MODELS 36/41, 51/55, 42/242, 254, 262, 281/288, 394, 3120

TANK CAP

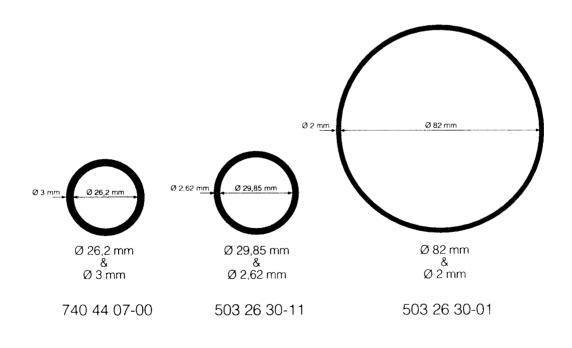
Husqvarna has 3 different types of tank caps for the models mentioned above. One oil tank cap for small saws and two fuel tank caps (these are also used as oil tank caps on the models 281, 288, 394 and 3120). The difference between the two fuel tank caps are the size of the O-ring/ sealing ring. See the table!

Ref. no. 503 26 30-11 is a standard version and ref. no. 740 44 07-00 is an oversize version to be used if leakage occurs.

All models are delivered with a standard O-ring (tank cap compl. 501 81 96-02). The only exception is the fuel tank capon the models 3120. It has the ref. no. 503 14 38-01 with an oversize O-ring ref. no. 740 44 07-00. See the illustration.
